ADDENDUM TO AURA BROOK FLOOD INVESTIGATION REPORT, REVISION E

Author(s)	Ashleigh Maynard & Daniel Yates
Entity	Egis Water Resources QLD
Version	A
Reference	18-000340-TM07A_Aura_Brook_Addendum

The following memorandum responds to Item 1 within the Further Issues Letter (DEV2018/987/210) received from Economic Development Queensland on the 29th August 2024, in relation to the Material Change of Use, Reconfiguring a Lot and Operational Work Applications for 167 Bells Creek Road, Bells Creek. Item 1 of the letter specifically refers to a query regarding the *Aura Brook Flood Investigation Report – Revision E* (Report No. 18-000340_FIR.01E.LM.dy.am dated 24th July 2024). It is intended that this technical memorandum forms an addendum to the Aura Brook Flood Investigation Report, Revision E.

FIGURE 1-1 - PEAK FLOW REPORTING LOCATIONS

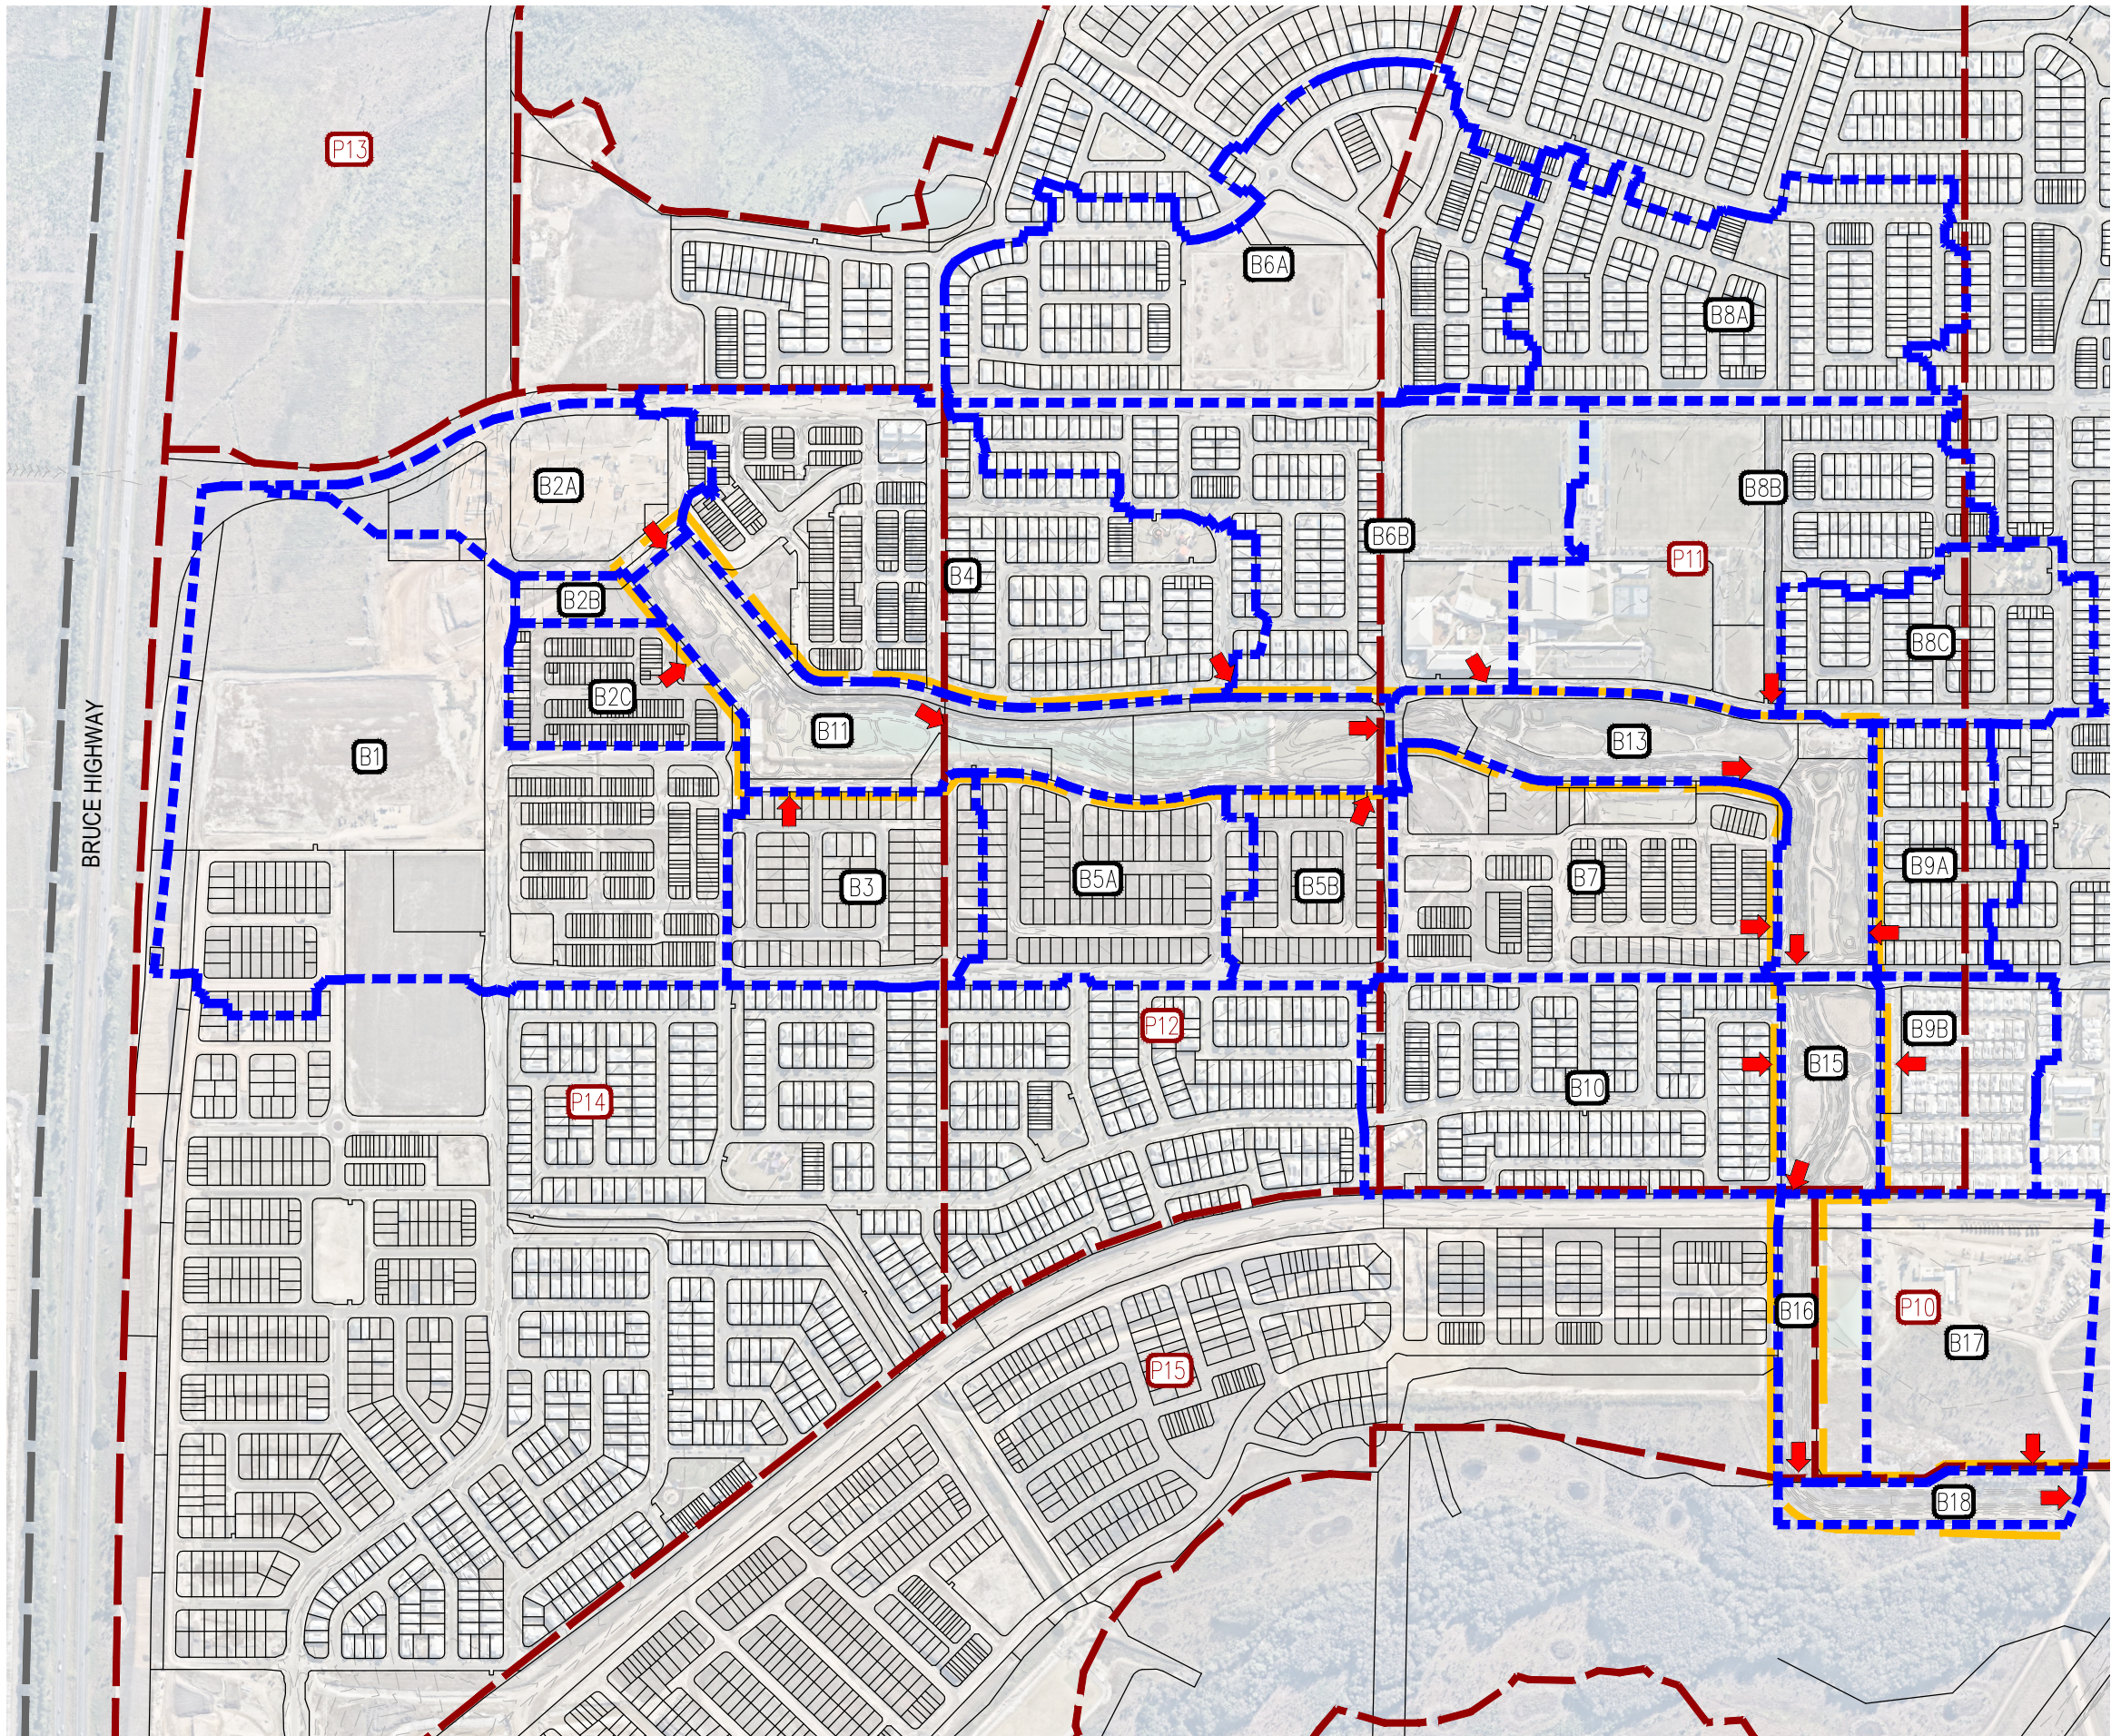
The query requested further justifications of how overall reductions in peak flows are achieved in comparison to the previously approved report (Report No. 18-000340_FIR.01D.LM.dy.jh dated 9th March 2021). The memorandum presents comparative catchment parameters between the two report revisions in addition to corresponding peak flow differences at specific reporting locations. Direct correlation has been established between the changed catchment parameters, constriction of the channel cross section and the differences of peak flows.

A peak flow comparison between the two report revisions is provided in **Table 4**. At Link 20, the reduction in peak flows is directly related to the Catchment B1 flow redirection downstream as previously detailed in **Section 1**. Reductions in peak flow are also demonstrated across all storm events at Links 21 and 22. This is explained through a reduced conveyance area within the channel resultant from the removal of the lake which previously fronted Catchment B4 and Catchment B5A. This reduced conveyance area has resulted in reduced peak flow. This has also impacted Link 24 during the 1% AEP plus climate change storm due to larger cumulative reductions as depicted below.

Links 24, 44 and 26 show increased peak flows for all storm events except for the 1% AEP plus climate change. This is directly related to the increase of catchment and impervious area detailed within **Section 1**.

Through the comparisons provided herein, it is concluded that the differences in reported peak flows between the Aura Brook Flood Investigation Report Revision E and D are adequately justified.
